REQUEST

Current Zoning: MUDD-O (mixed use development, optional)
Proposed Zoning: MUDD-O SPA (mixed use development, optional, site plan amendment)

SUMMARY OF PETITION

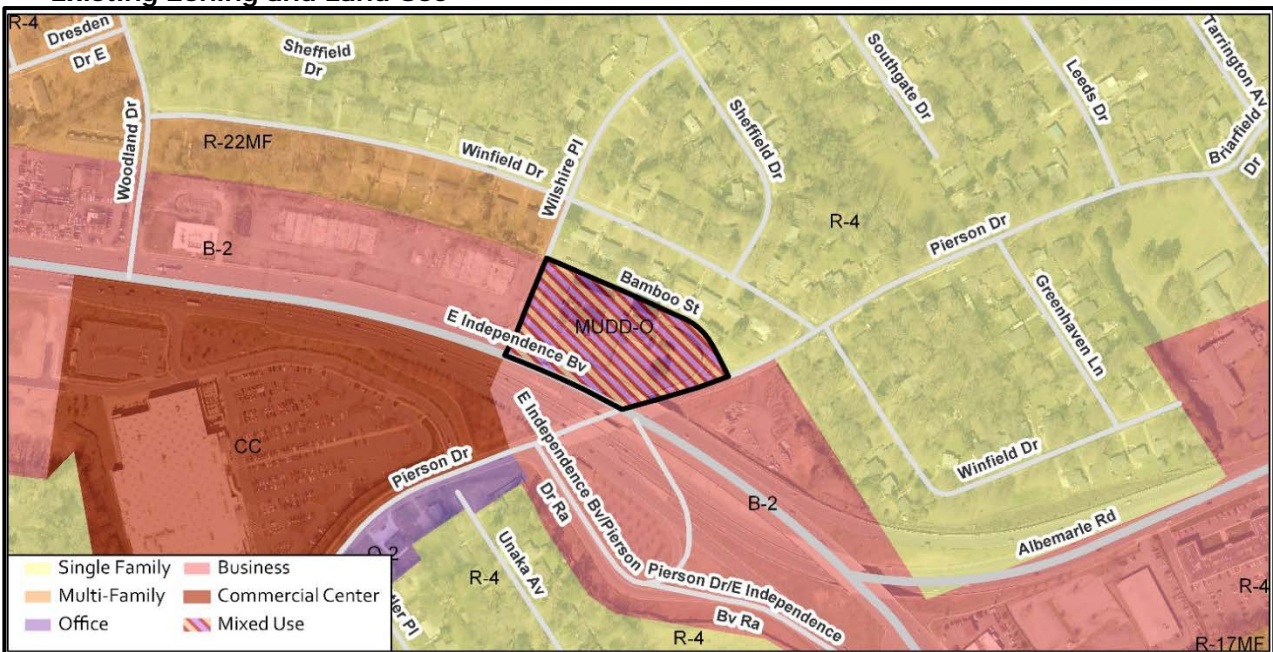
1. Revise the site plan to add a note specifying dedication and fee simple conveyance of all rights-of-way to the City before the site's first building certificate of occupancy is issued. CDOT requests right-of-way set at 2 feet behind back of sidewalk where feasible.

2. Revise the site plan to add a note specifying all transportation improvements will be approved and constructed before the site's first building certificate of occupancy is issued. The petitioner may phase transportation improvements if said improvements and phasing are explicitly described in site plan notes.

3. Add a conditional note to specifying replacement of the existing CATS bus stop pad as indicated by the site plan.
4. Revise the site plan (RZ-2) to show the existing stairs that are shown in the sidewalk area along Bamboo Street to be removed from the right-of-way. In addition, please propose to install a safety rail or a gated system to prevent pedestrians, within in the right-of-way, from falling into the drop-off.

5. Revise the site plan (Sht. RZ-2) to clarify whether the existing driveways on Bamboo Street will remain or be replaced. Sheet RZ-2 calls for the existing driveways to remain, but the site plan shows the existing Commercial Type II Driveway to be replaced with a Type II Modified Driveway at the access west of the existing Ervin building.

6. Revise the site plan (RZ-2) to include proposed and existing sidewalk labels and dimensions.
